City of Ryde Submission to RTS

**NEXTDC S5 Data Centre and
Innovation Hub at 269 Lane Cove Road,
Macquarie Park
SSD-63168959**

**Submission Date: 11 December 2025
Council Reference: COR2023/160/3**

Figure 1: Mark up of Public Art Map (Base Source: Macquarie Park Design Guide)

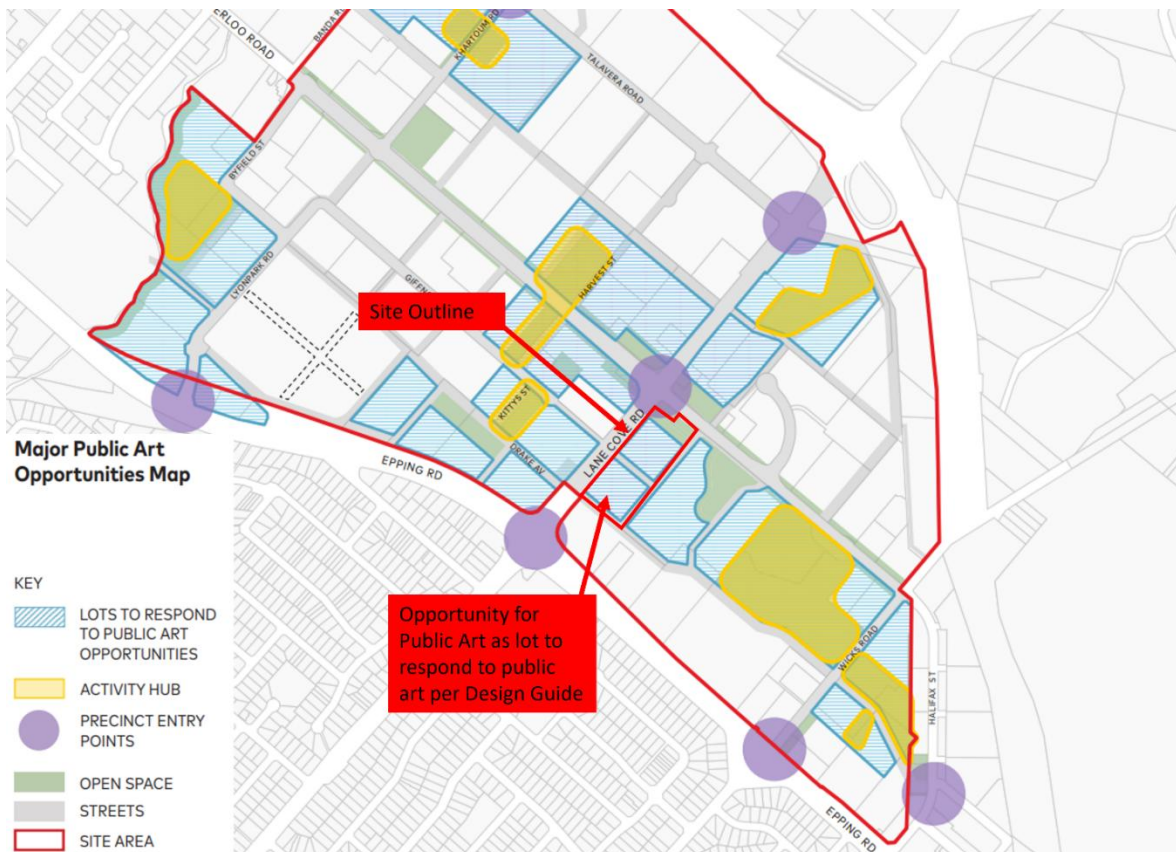
- Public Art/ Mural could be explored on the façade. As this location will be a future pedestrian throughfare due to the future pedestrian bridge, its considered an appropriate location to provide a mural.
- Explore public art opportunities that respond to the site's gateway location, to a sum equivalent to 1% of the construction cost as per Ryde's DCP and public art policies.
- Council notes that Public Art is required by both the Macquarie Park DCP and the Macquarie Park Urban Design Guide.
- Explore additional articulation of the building face to offset building bulk.
- Explore vertical gardens.
- Given the high visual profile of what is a gateway site to the Macquarie Park Improvement Precinct, and its identification on the Major Public Art Opportunities Map in the Macquarie

Park Design Guide, the structure should be utilised to make an artistic entry statement for the Precinct. (Figure 1)

Figure 2: Viewpoint 1 illustrates a significant blank wall that is highly visible from the northbound lanes and footpath of Lane Cove Road.

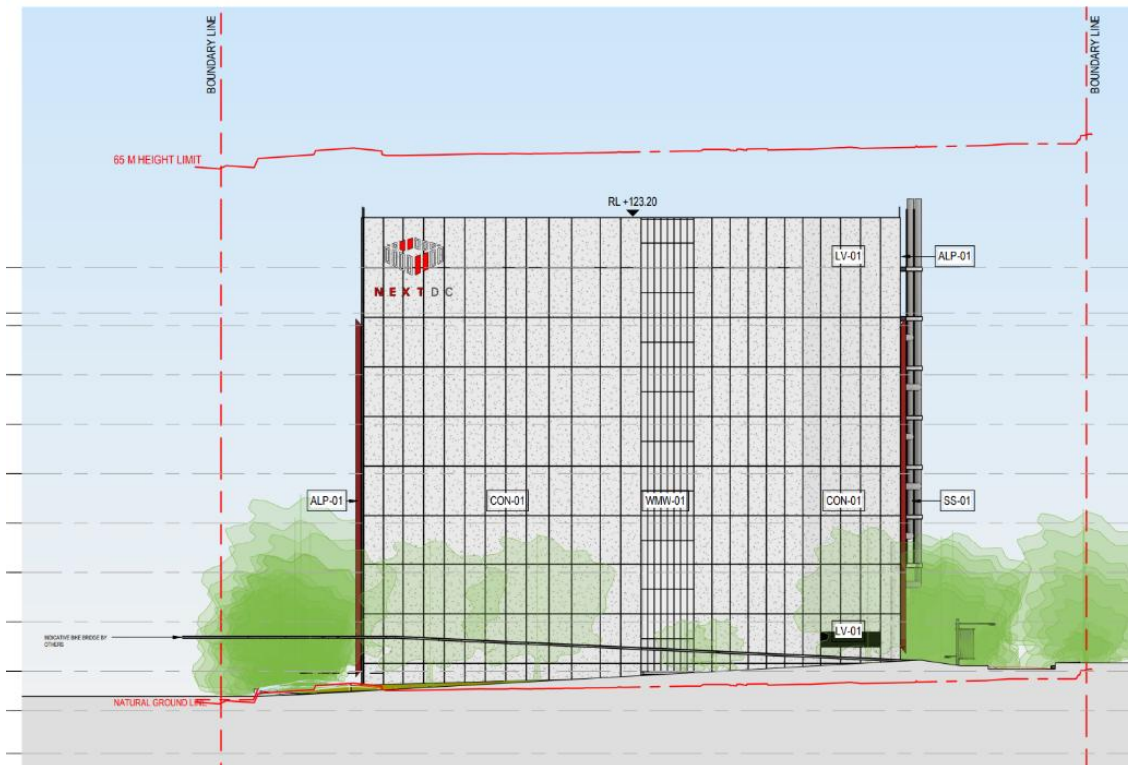
West elevation: This façade is not addressed in the "Façade Design and Materiality" section in the Revised Architectural Design Report. The architectural drawings show a blank wall approximately 64m wide and generally 55m high. The absence of sufficient design treatment for this elevation creates a visually dominant and monotonous streetscape. Figure 2 , Figure 3 and Figure 4 demonstrate the blank wall.

1. Revisit the façade design of western elevation of Building B and the eastern elevation of the data hall levels of building A to mitigate the “monolithic” appearance and enhance visual amenity within the public domain. It is recommended to considering the followings:

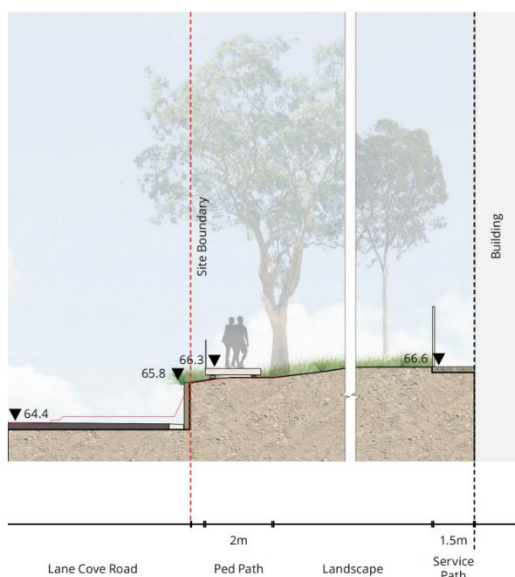
Concerns regarding the spatial relationship between the proposed pedestrian footpath and the overhead pedestrian bridge ramp along Road 6 associated with the constraints of the movement were raised during the latest engagement in August. These issues have not been addressed or responded to in the revised scheme package. Council has further concerns about passive surveillance for pedestrian movement beneath the ramp, where it interfaces with an inactive frontage along Road 6. In addition, the elevated pedestrian path along Lane Cove Road widening, combined with the vegetation buffer, lacks passive surveillance.

2. Address council’s concerns by providing alternative design solutions for the pedestrian bridge ramp and adjacent pedestrian path to ensure safety, comfort and accessibility, while incorporating sufficient lighting and maintaining clear sightlines.

Figure 7: Mark up showing external site trees for removal (Base Source: Arborist Report by CPS).

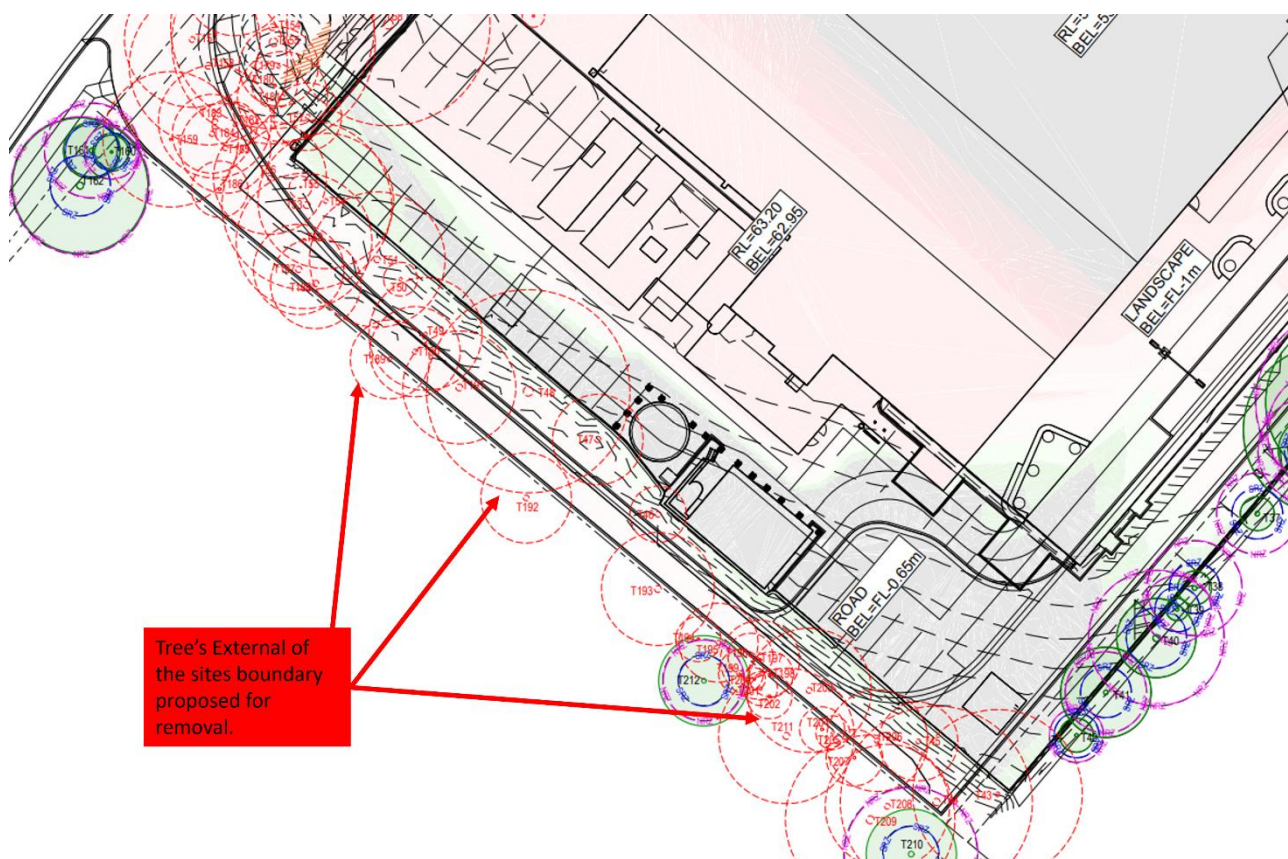
The revised Arboricultural Impact Assessment by CPS dated 9/10/2025 shows the removal of several trees outside the boundaries located in adjoining properties including trees 192, 193, 211, etc. However, no written permission to remove these trees from the owners of these trees has been supplied.

Clarification is sought as if the application is seeking to remove trees external of the site, and that the applicant has obtained landowners consent to remove the identified trees.
